4-10-17 Consent Item A

**From:** Mindi Messmer <mmessmer@me.com>  
**Sent:** Sunday, April 2, 2017 1:15 PM  
**To:** Janice Ireland  
**Cc:** david@davidbordennh.com; Nancy Stiles; reprennycushing@gmail.com  
**Subject:** Coakley Landfill Superfund Site Legislative Correspondence - Rye Select Board  
**Attachments:** 3-22-2017 letter to EPA DES.pdf; ATT00001.htm; Response to Coakley 4th 5-year review.pdf; ATT00002.htm; EPA letter to CLG re new monitoring wells and decomisioning.pdf; ATT00003.htm; NW GMZ Well Locations (002).pdf; ATT00004.htm

Re: Comments on Fourth Five-Year Review Report for Coakley Landfill  
Superfund Site, Rockingham County, New Hampshire, dated 9/26/16

Subject: Comments on Work Plan for Installation of New Monitoring Wells proposed for the Northwestern Portion of Current Groundwater Management Zone (GMZ), Coakley Landfill, Greenland, NH.

## Coakley Landfill Superfund Site

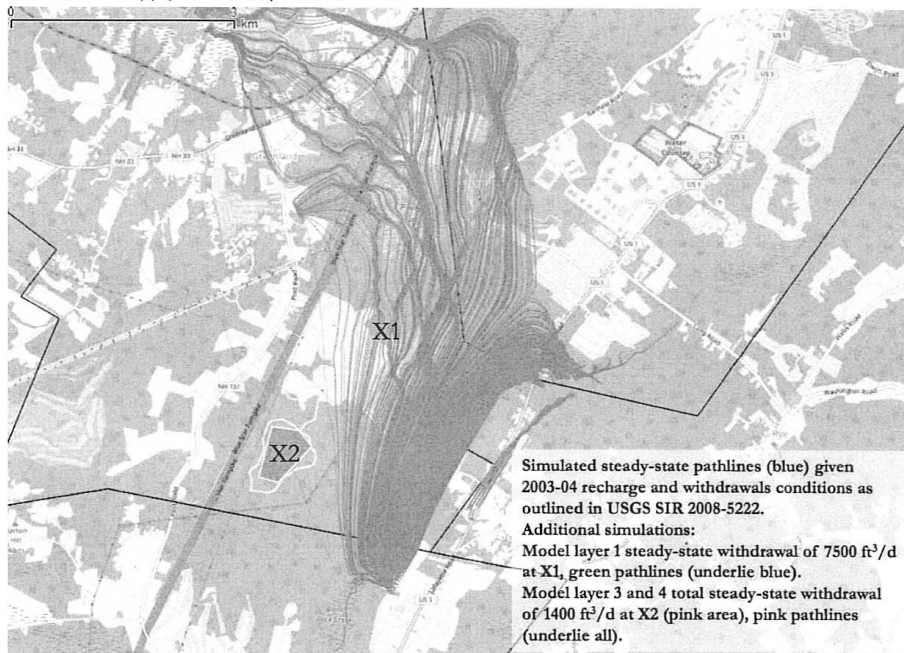
- **EPA needs to use a version of the USGS Groundwater Model at Coakley to assess the current and potential flow of PFCs into the groundwater.** Preliminary model estimates (below) show migration from the dump to the irrigation well but also beyond the Greenland well which serves as the water supply for the City of Portsmouth.
